DRC Violation that can be Waived

Date: 01/05/2010

There is DRC violation about the RPO (silicide block) size in this cell.

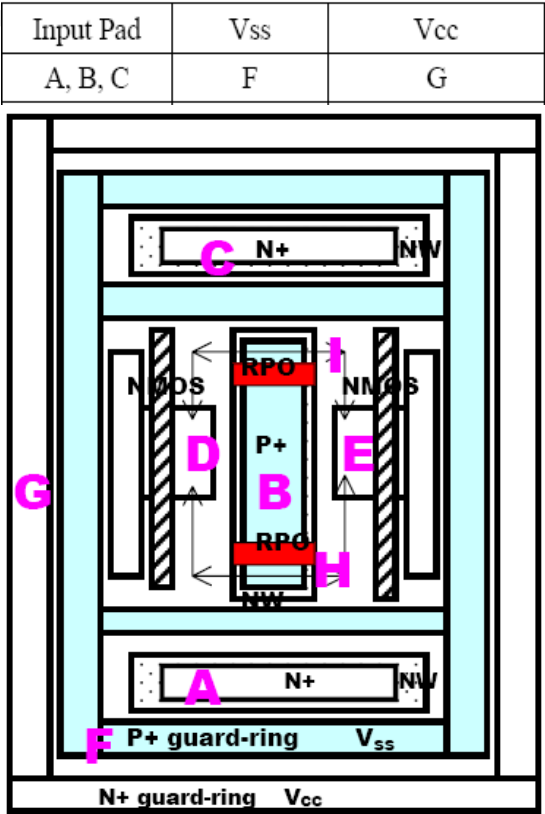
2.1 Rule: RPO.A.1

Description: Minimum area of RPO $\geq 2 \text{ um}^2$

Root Cause: This small RPO is used for creating small resistors to limit the drain passing current.

Waive Reason: There is silicon data on hand to prove the cell's performance.

Please waive this DRC violation in the LCESD cell.
